REACTOR CORE SAFETY LIMIT - THREE LOOPS IN OPERATION

Attachment 4 to  
L-95-250

FIGURE 2.1-1

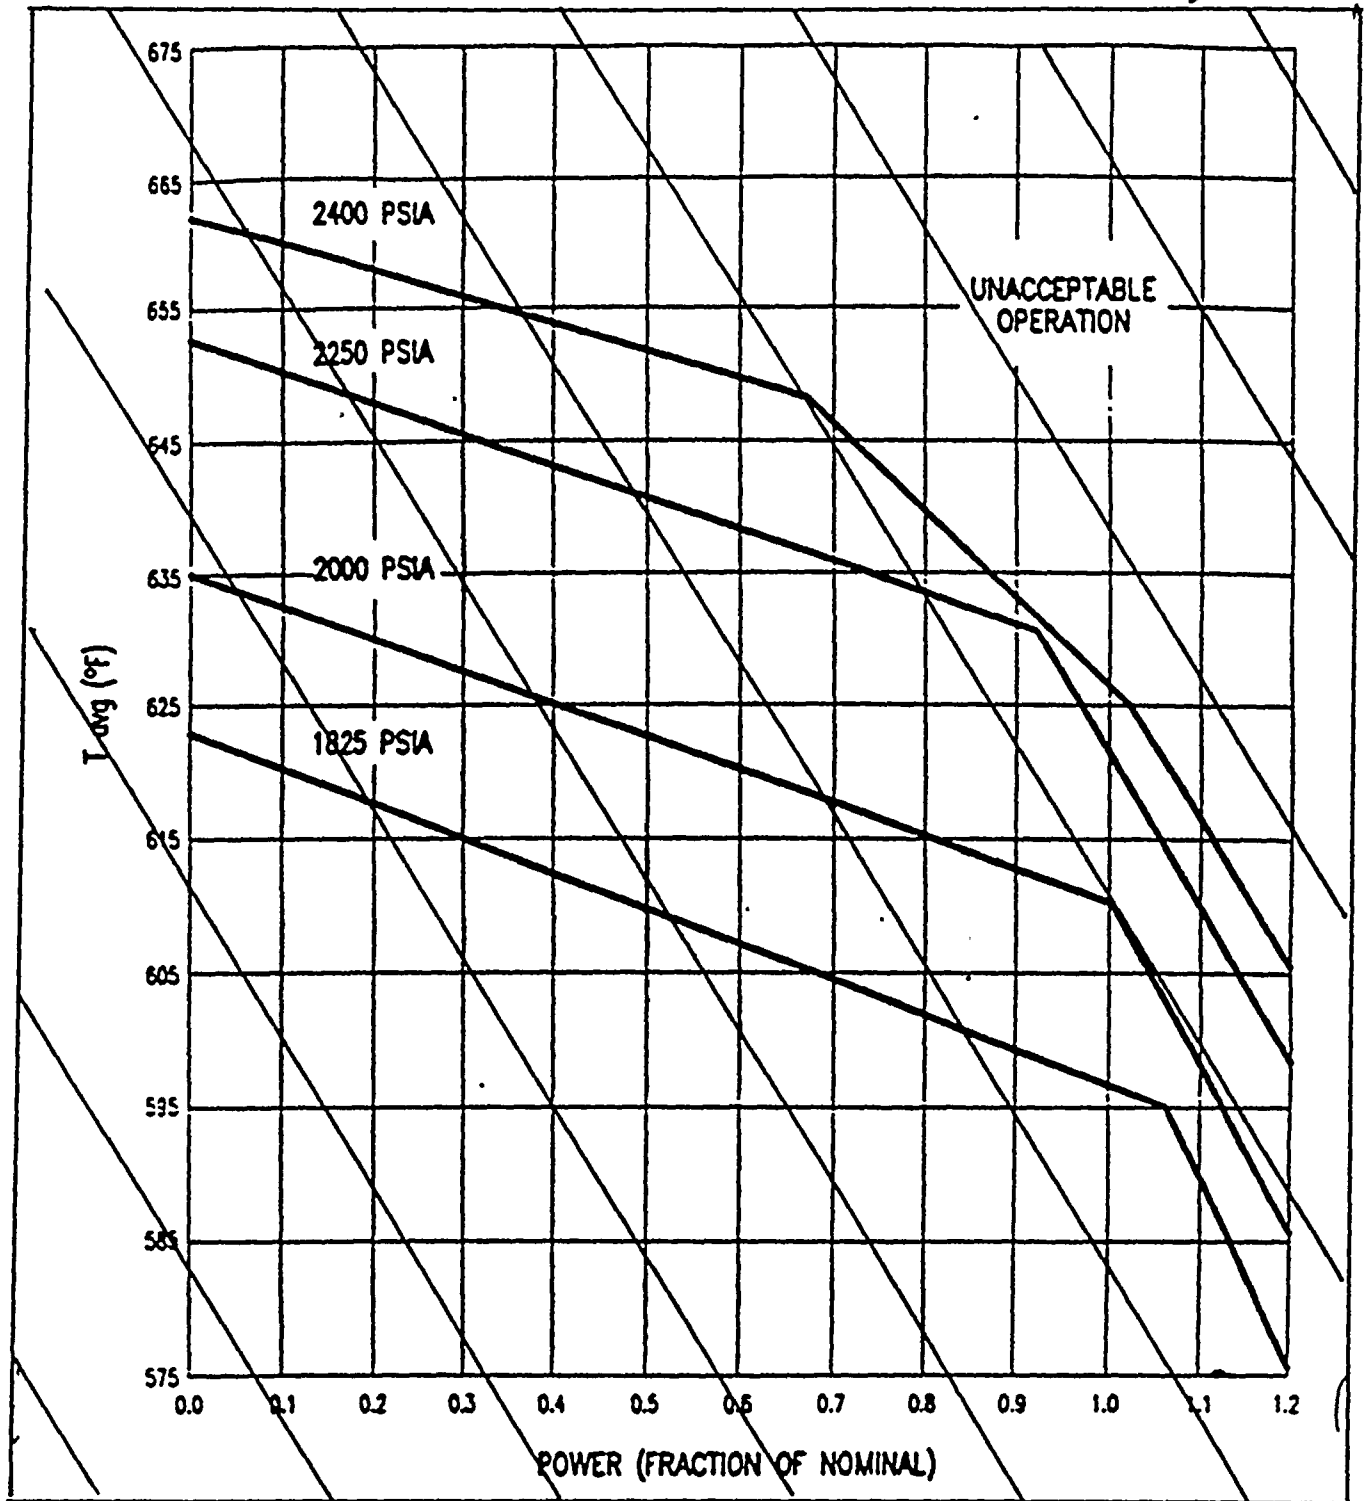
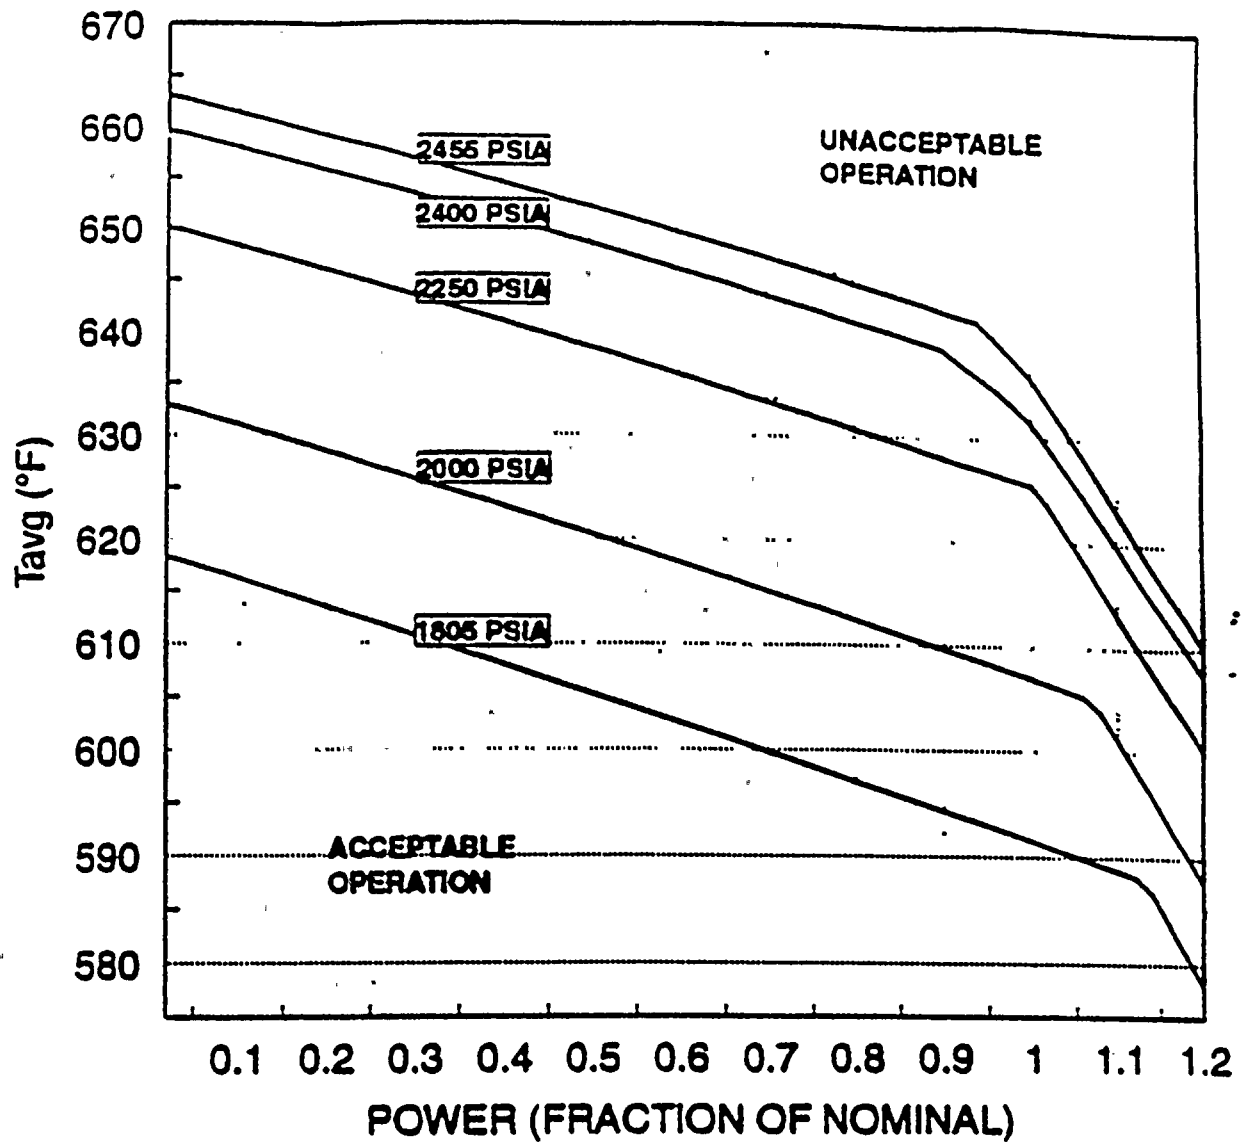
INSERT 'A' HERE
